Access Compliance Report

Public Rights-of-Way

(Curb Ramps)

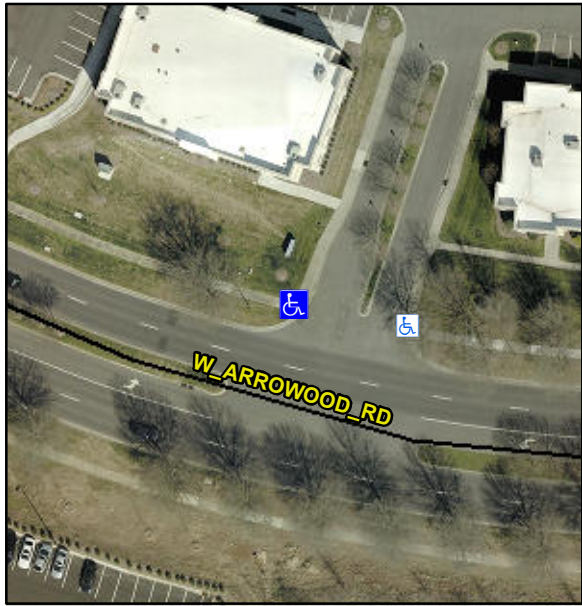
Intersection ID: 10040584		Main Street: W_ARROWWOOD_RD		Cross Street: N/A		Location:		NW											
ADA ID: D6A51C3110A4		Ramp Type: Directional1		Initial Pass/Fail: Pass		Overall Compliance: No		Severity Score: 10											
Codes/Mitigation Info/Possible Solution				Field Measurements/Component Compliance															
 <div>Street 1 NameENTRANCE</div> <div>Stop Condition-Street 1StopSign</div> <div>Street 2 NameN/A</div> <div>Stop Condition-Street 2N/A</div>				Possible Solutions:		Compliance		Description		Data		Compliance		Description		Data			
				Remove & Replace Entire Ramp.		N/A		Ramp Length (in)		69.0		No		Grade Break?		No			
						Yes		Ramp Width (in)		61.0		N/A		Grade Break Slope (%)		5.8			
						Yes		Ramp Slope (%)		7.2		N/A		Grade Break XSlope (%)		5.0			
						Yes		Ramp XSlope (%)		0.4									
						N/A		Flare Type LT		N/A		N/A		Flare Type RT		N/A			
						N/A		Flare Slope LT (%)		9.2		Yes		Flare Slope RT (%)		4.2

Surveyor Notes:		N/A		N/A		Flare Traversable LT?		No		N/A		Flare Traversable RT?		Yes	
								Yes		Landing Length (in)		59.0		No		DWS Provided?		No	
								Yes		Landing Width (in)		60.0		N/A		DWS Contrast?		No	
				No		Landing Slope (%)		6.5		N/A		DWS Length (in)		N/A					
				Yes		Landing X Slope (%)		1.2		N/A		DWS Full Width?		No					
				N/A		Landing Curb? (Y/N)		N/A		N/A		DWS Offset LT (in)		N/A					
				N/A		Shared Landing?		No		N/A		DWS Offset RT (in)		N/A					
				Yes		Gutter Ponding?		No		Yes		Gutter Slope (%)		2.4					
				Yes		Gutter Lip Ht (in)		0.0		Yes		Gutter X Slope (%)		1.3					
				N/A		Painted X Walk1?		No				Road Slope (%)		3.4					
						X Walk 1 Direction		To E				Road X Slope (%)		1.3					
						X Walk 1 Width (in)		N/A				Clear Space?		Yes					
						X Walk 1 Slope (%)		3.4		N/A		Clear Space to XWalk (in)		N/A					
						X Walk 1 X Slope (%)		1.3		Yes		Storm Grate/Utility Hazard?		No

N/A		Ramp inside XWalk1?		N/A				Storm Grate/Utility Type							
				Yes		Any Obstructions?		No						N/A					
						Obstruction Type				Yes		Surface Condition? (G/P)		Good					
										N/A		No		Curb Slope (%)		15.5			
Total Cost:				\$		1600.00
